SOMERSET MASTER PLAN

Lot : HF 206
 Address : 2222 SW Heartland Ct, LSMO

RELEASE FOR CONSTRUCTION
 AS NOTED FOR PLAN REVIEW
 DEVELOPMENT SERVICES
 LEE'S SUMMIT, MISSOURI
 02/25/2025

1 Main Level Floor Plan
1/4" = 1'-0"

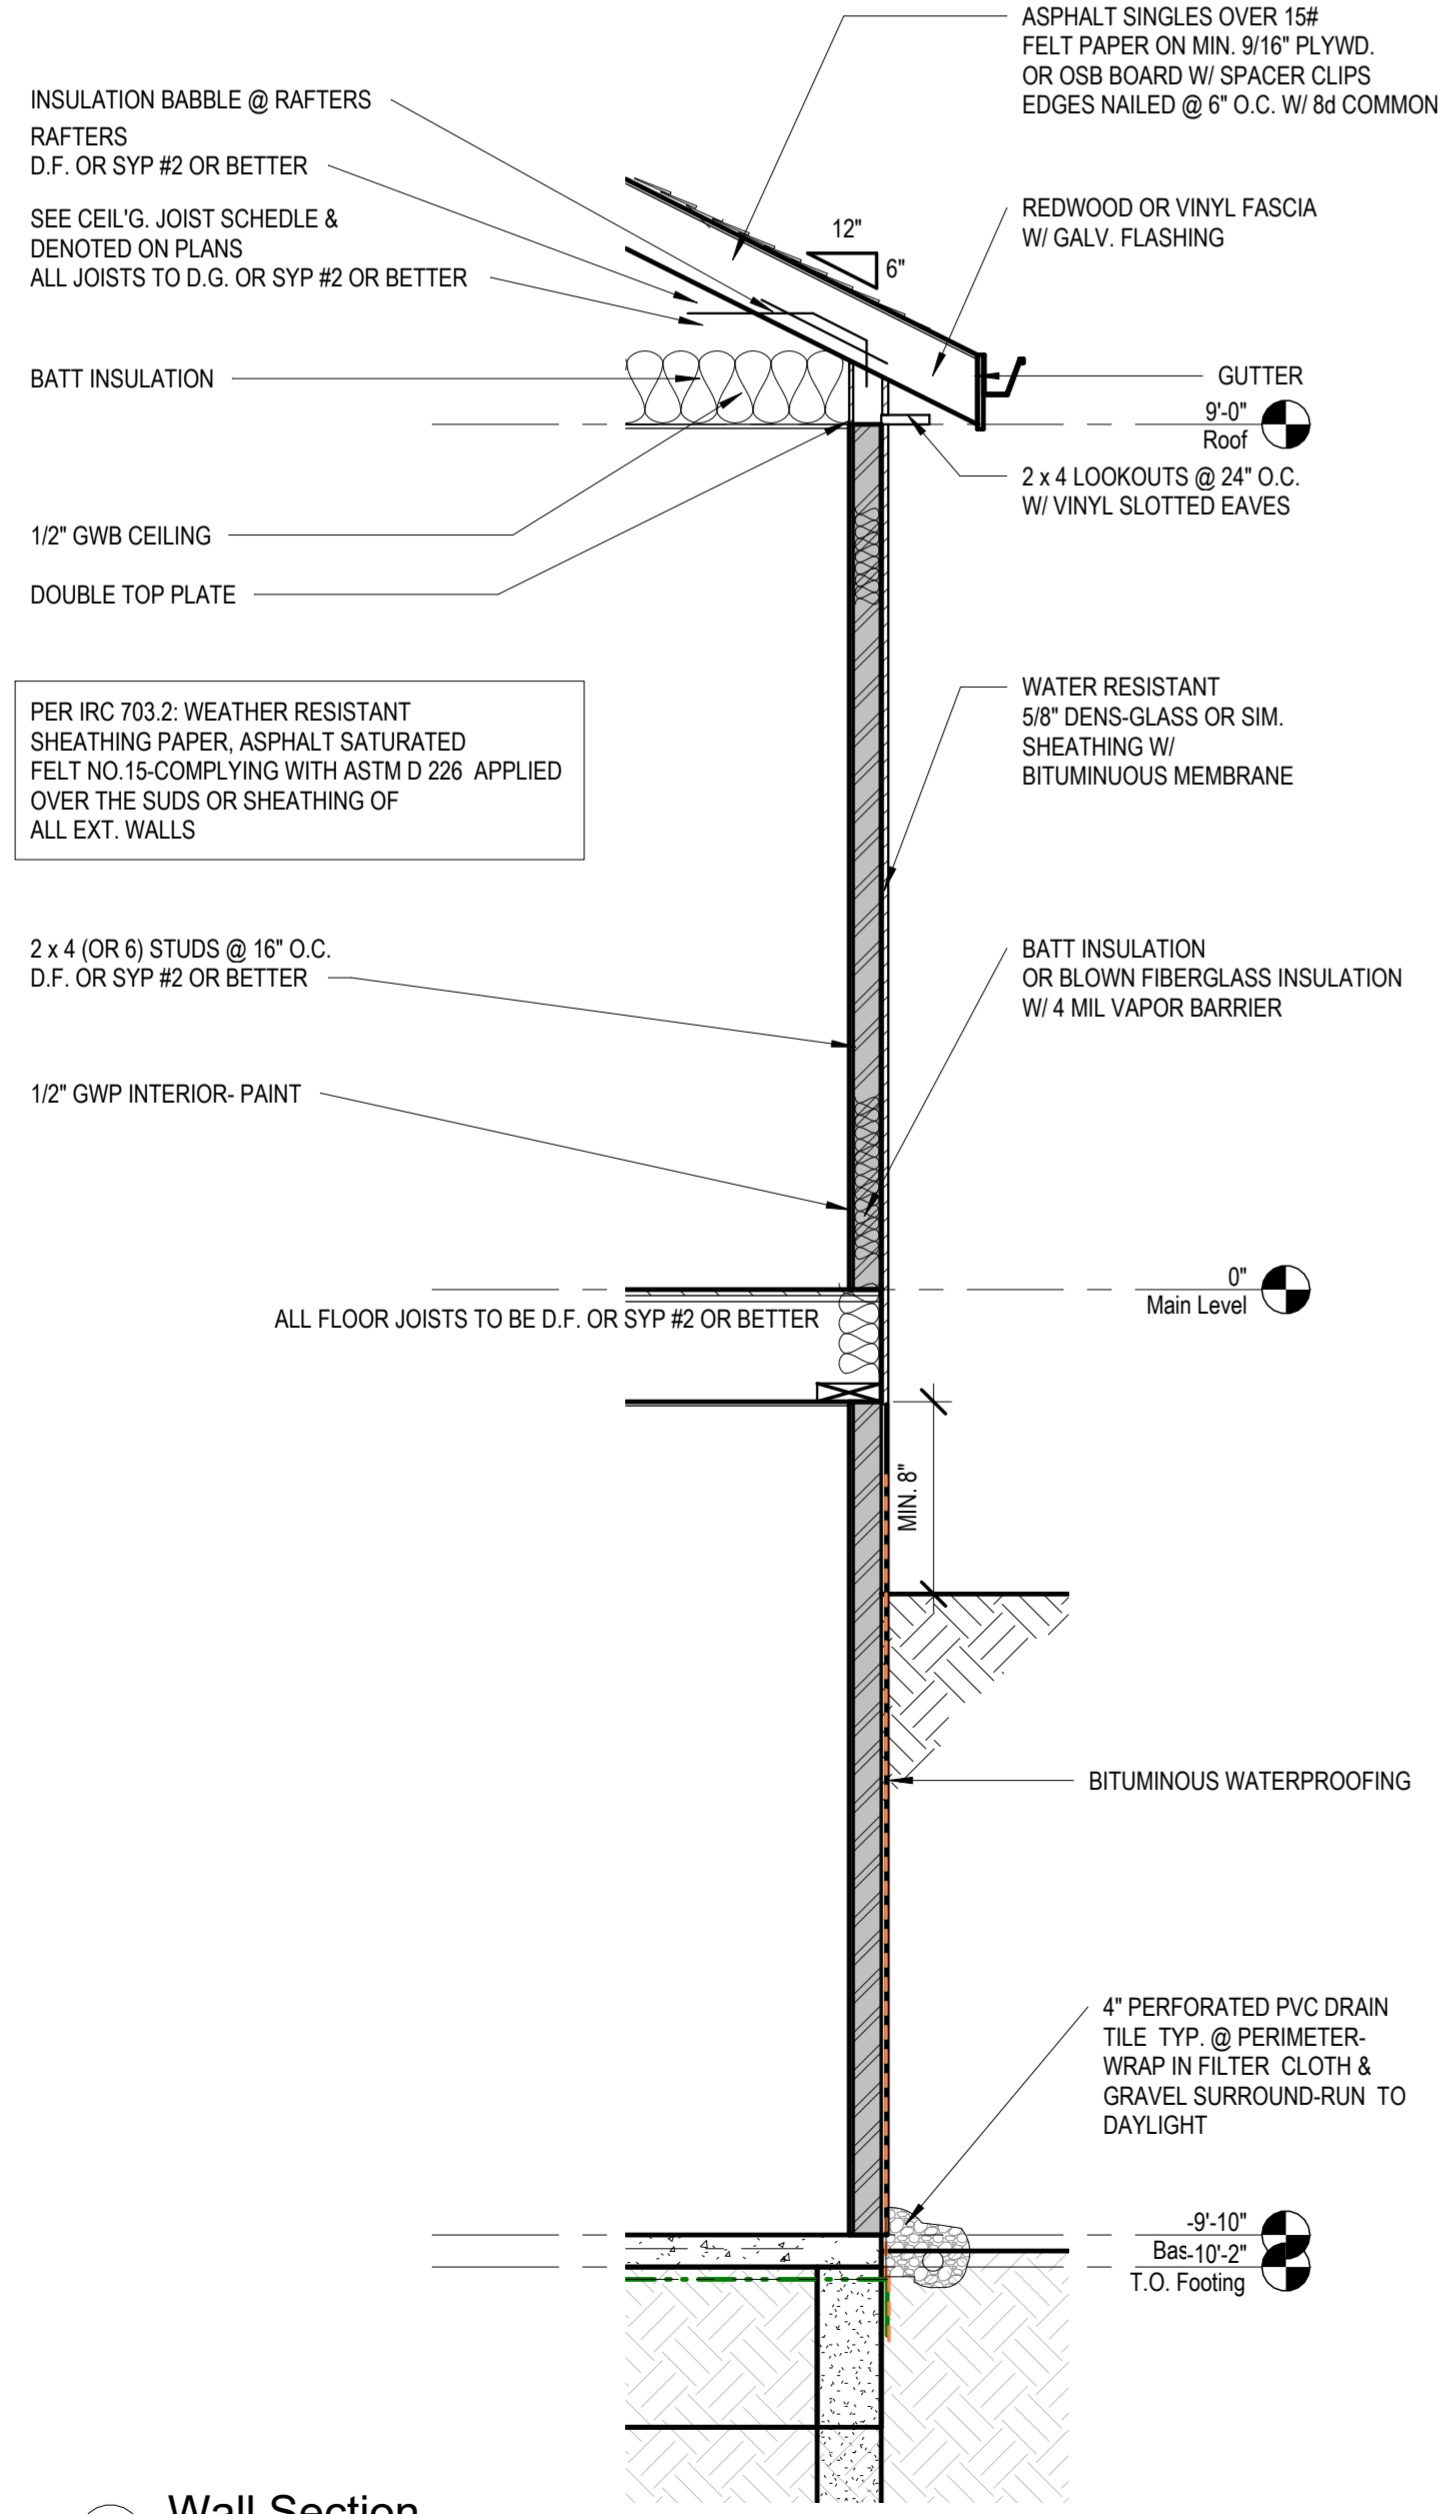
Move Micro to Pantry

Micro on counter
